167 STAFFORD ROAD

APPROVED
PARKING AREA SITE PLAN
JUL 27 2011
TOWN OF MANSFIELD
HOUSING INSPECTION

Proposed Parking Plan

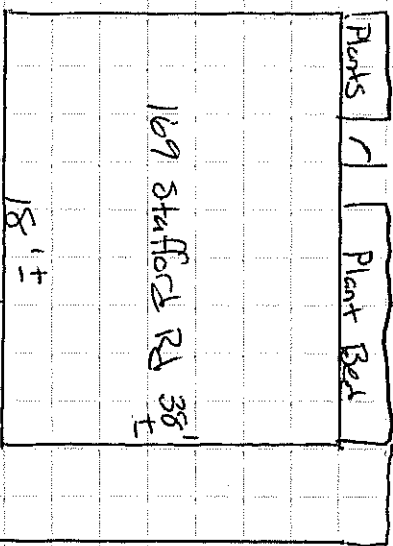
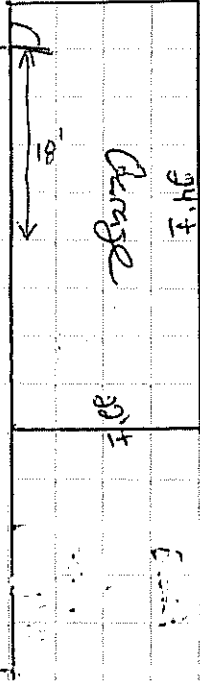
Approved with no barriers due to no history of parking issues. Barriers may be required if issues arise.
